REVISED
CITY OF SEATTLE
ANALYSIS AND DECISION OF THE DIRECTOR
OF THE DEPARTMENT OF PLANNING AND DEVELOPMENT

Project Number: 3012729
Applicants Name: Paul Buchanan
Address of Proposal: 133 14th Avenue East

Land Use Application to allow a four-story, 42 unit residential building over four live-work units. Parking for 24 vehicles located below grade. Existing structure to be demolished.

MASSING OPTION A

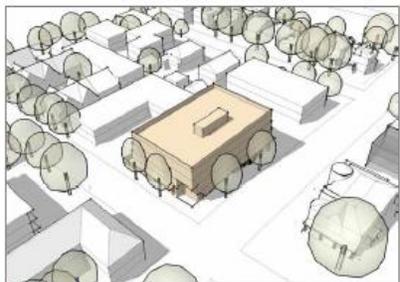
The first scheme (Option A) showed a rectangular building mass with articulation of the corner base.

MASSING OPTION B

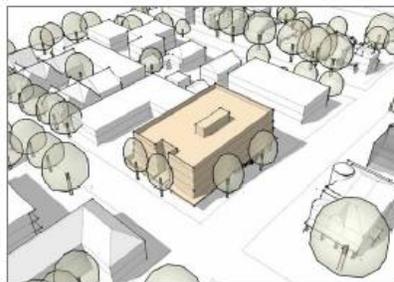
The second scheme (Option B) showed a rectangular massing with a vertical notch on the east side facing 14th Avenue and a ground level entry courtyard.

MASSING OPTION C - PREFERRED SCHEME

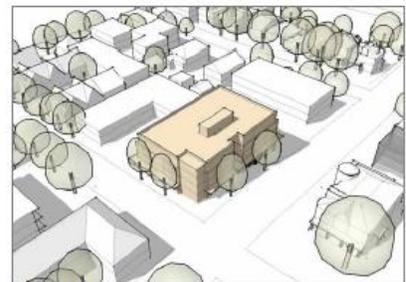
The third and preferred scheme (Option C) showed a rectangular massing with corner articulation and a vertical notch along the John Street facade.

At the Early Design Guidance Meeting, the Board agreed that the corner location is important and that the preferred alternative provides a solid corner expression. The transition between the building mass and the ground level design and proposed live/work uses will be a crucial issue to review at the next meeting. How the corner expression relates to the rest of building body flanking the corner is also essential. The Board also noted that the proposed development should take advantage of the topographical changes of the site's location and views.

At the Early Design Guidance Meeting, the Board noted that the vertical modulation shown in the preferred option, along with high quality materials and a strong architectural design concept and the full required setback along the south side of the site would provide a sensitive transition to the zone edge. The Board was supportive of the building
